RE: **STAFF SUMMARY REPORT**
LARGE-SCALE DEVELOPMENT PLANS – CULVER’S

PROJECT NAME:	Culver’s
ADDRESS/LOCATION:	4202 & 4204 W. New Hope Road
PROPOSED USE:	Restaurant, Retail, and Commercial
CURRENT ZONING:	C-2 (Highway Commercial) and Overlay District
CGM GROWTH DESIGNATION:	Regional Center
APPLICANT/REPRESENTATIVE:	Crafton Tull / Daniel Ellis
PROJECT OWNER/DEVELOPER:	Sandhu Food Group, LLC
PROPERTY OWNER:	Sandhu Food Group, LLC
NATURE OF REQUEST:	Approval of Large-Scale Development Plans
AUTHORITY:	Chapter 14, Article III, Rogers Code of Ordinances

RE: Technical Advisory Committee Review/Conditional Re-Approval
Culvers

C-101

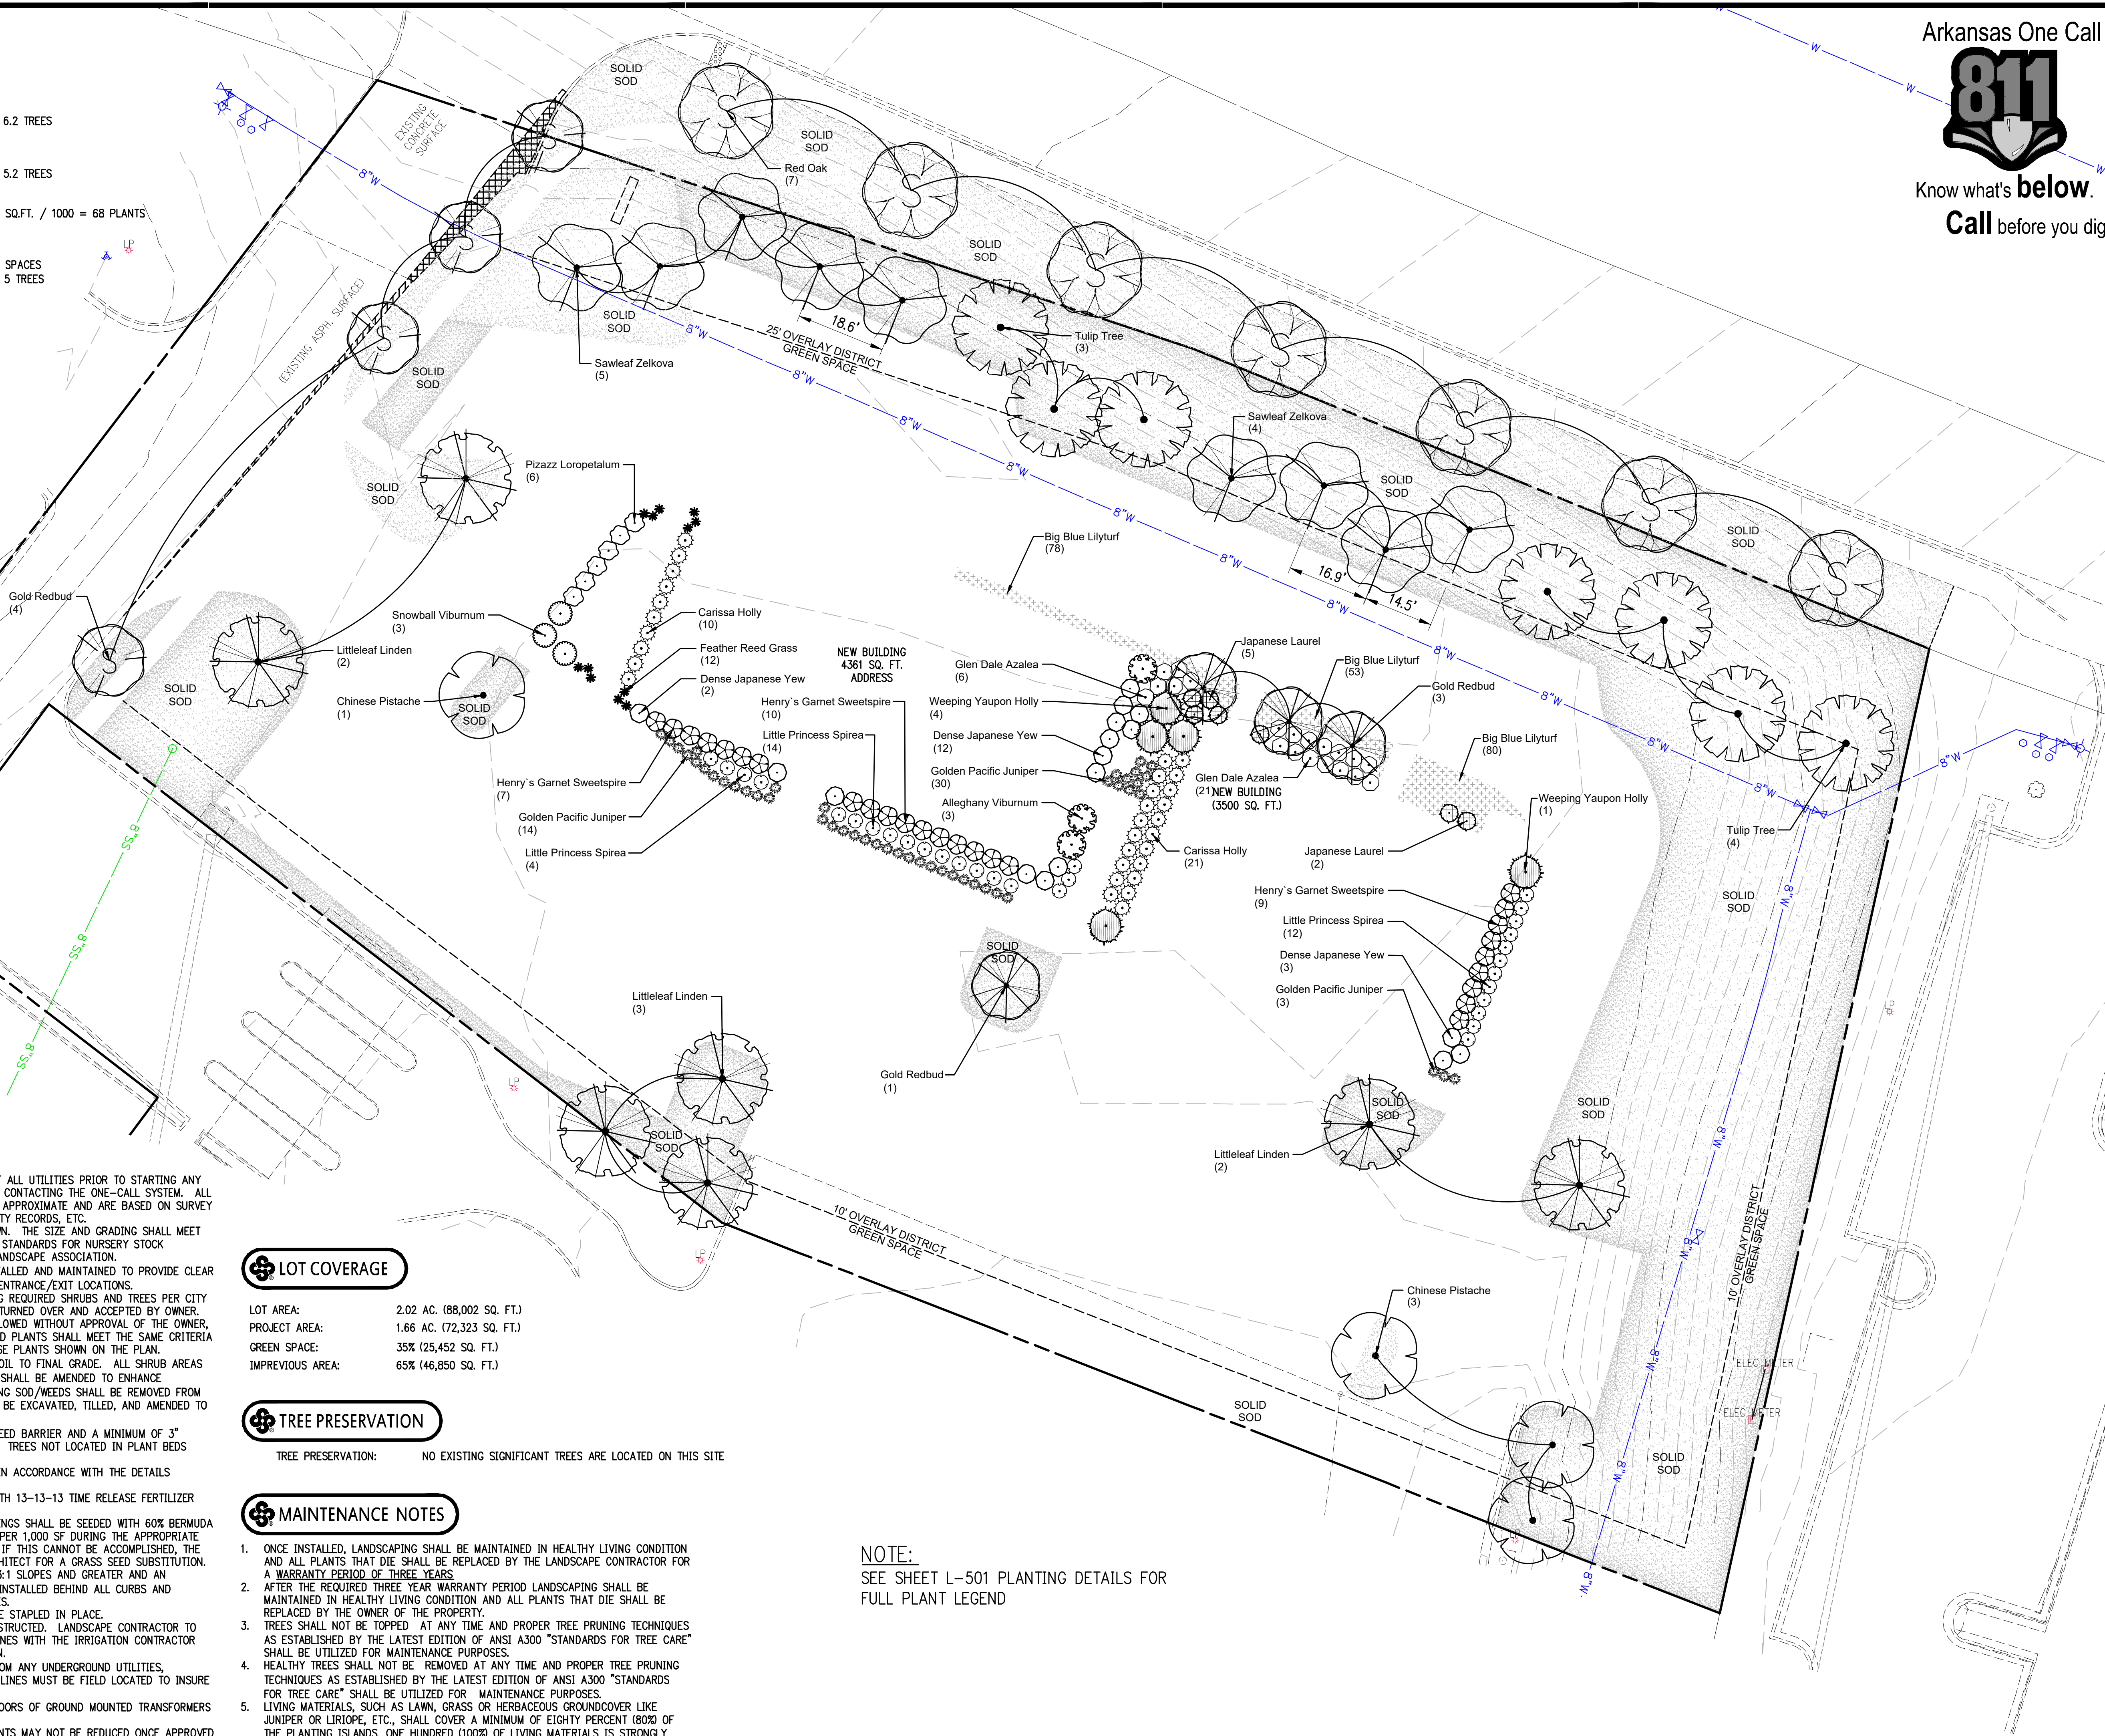
The applicant requests a **VARIANCE** from Sec. 14-285(4) from the Overlay District requirement to provide a landscape area along the side and rear yards that is no less than ten feet deep from the property line. All other landscaping requirements have been met.

- ii. Approve a **VARIANCE** from Sec. 14-285(4) from the Overlay District requirement to provide a landscape area along the side and rear yards that is no less than ten feet deep from the property line. The applicant states that the way this parcel was platted does not allow for this requirement to be met as shared parking along the south side and a private drive along the west side are necessary for the overall development. The applicant is providing more than double the required landscape area on the east side.

2. To allow less than required Overlay Greenspace Buffer along the East and South property lines.

This particular subdivision and the way it was originally platted does not lend itself to implementation of the full buffer requirements of the overlay district. The shared private drive, the location of the western boundary line, and shared parking all effect the Overlay buffer on the south and west sides of the development. We have placed the full quantity of trees required throughout the project on the site, and we have densely planted the New Hope Road frontage with Overlay District Trees.
